Comments on applications for referral under the COVID-19 Recovery (Fast-track Consenting) Act 2020

Project name	Verran Mews Project
General comment – potential benefits	Will add additional housing supply and choice in the Auckland region.
General comment – significant issues	- There are wastewater capacity constraints in the public wastewater line (see attached comments from Watercare for more details). - It is unclear whether there are other infrastructure restraints as little infrastructure information has been provided, in particular the management of stormwater. - The proposed development and increased impervious area will result in increased flow rates at the outfall locations to the stream. Slips have been identified within the catchment following the January and February 2023 storm events (see attached comments from Healthy Waters for more details). - The effects of the development on the existing downstream flood hazards are unclear and should be assessed further (see attached comments from Healthy Waters for more details). - Intended ownership or operation and maintenance responsibility of future stormwater quality management devices and other infrastructure has not been

Figure 1: Possible adverse effects from additional traffic on Verran Road east leg in the morning peak.

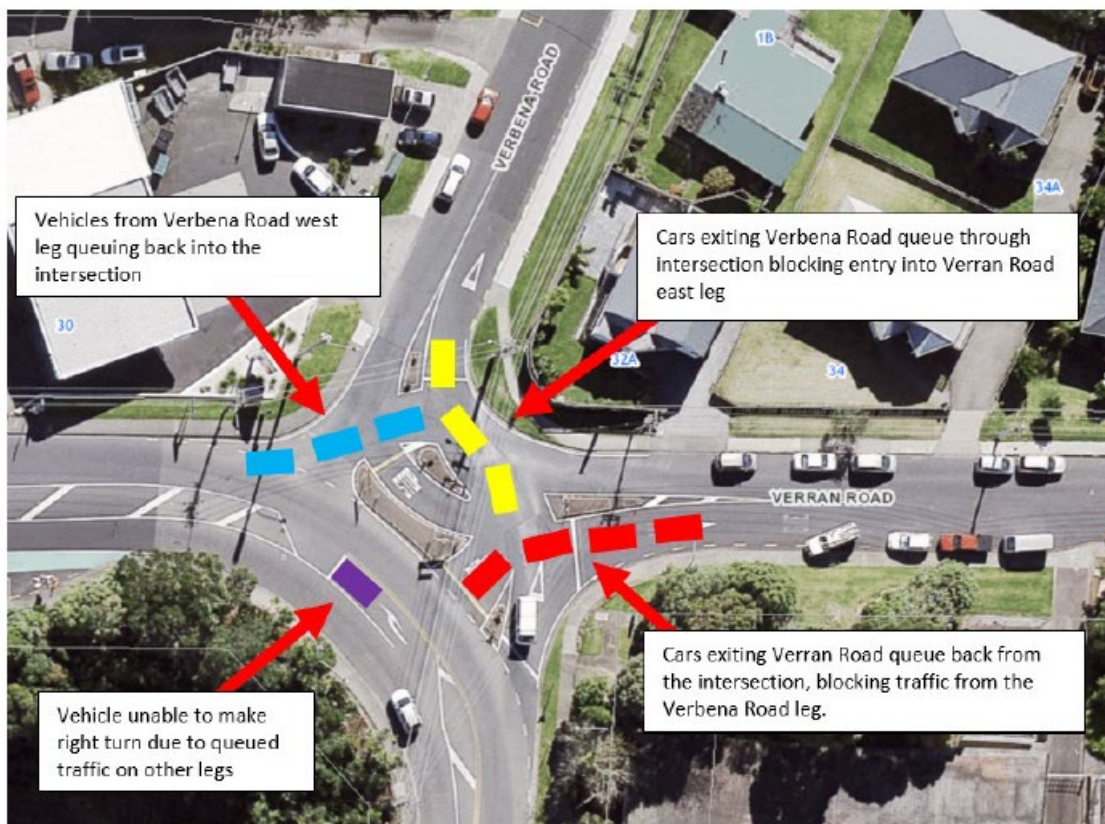
- Intersection of Verran Road, Waipa Street, and Verbena Road: This intersection has a unique layout, with all traffic travelling between the proposed development and the wider area will need to pass through it. This intersection currently has a good safety record in terms of the number of recorded crashes, however AT is concerned that the additional traffic entering from the east leg (Verran Road) during the morning peak could cause a problem if queued vehicles block other movements. This is illustrated in more detail in Figure 1.

Site assessment (Figure 1):

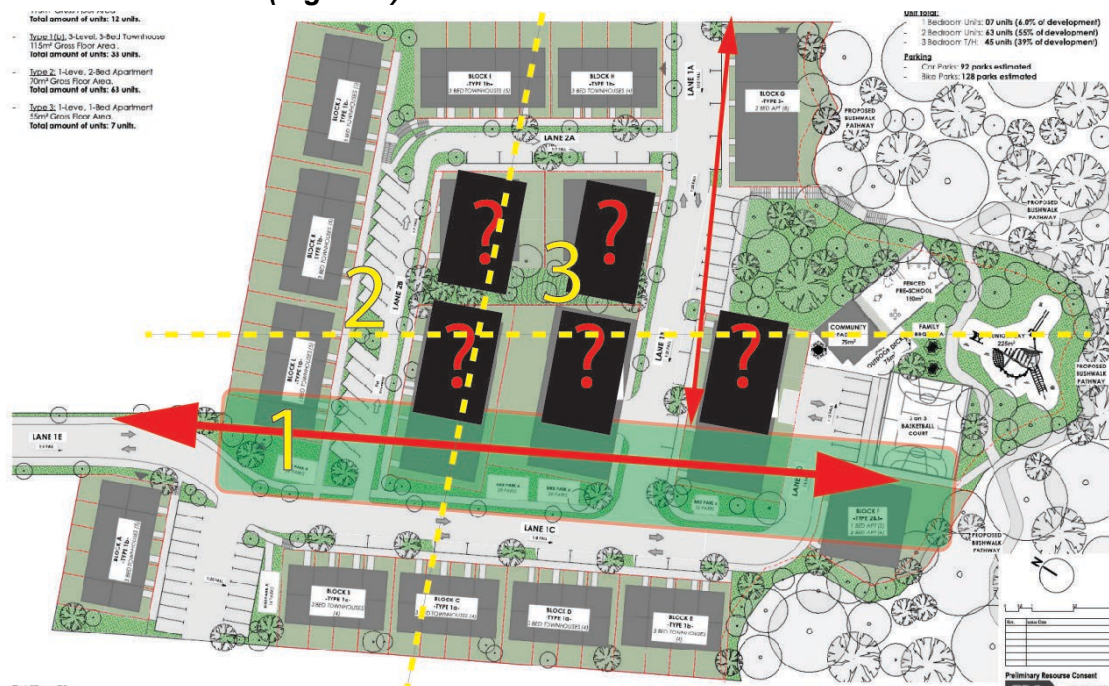
While common green areas are supported in principal, the proposed central green axis between apartments does not necessarily appear to correspond to desire lines or movement network. Given also that earthworks are likely to displace the current overland flow path, the rationale of this green link is unclear. A more activated green link could be better provided alongside the primary JOAL, from Verran Road and the common green areas (see Figure 1).

1. Opportunity for primary sightlines and movement network to be strengthened with corresponding green network.
2. Cross sections are needed to assess the gradient shifts and typologies within the site (indicative locations only).
3. Further consideration of apartment layout and rationale is needed to ensure positive interface between buildings as well as at the interface with the street/JOAL and common green spaces.
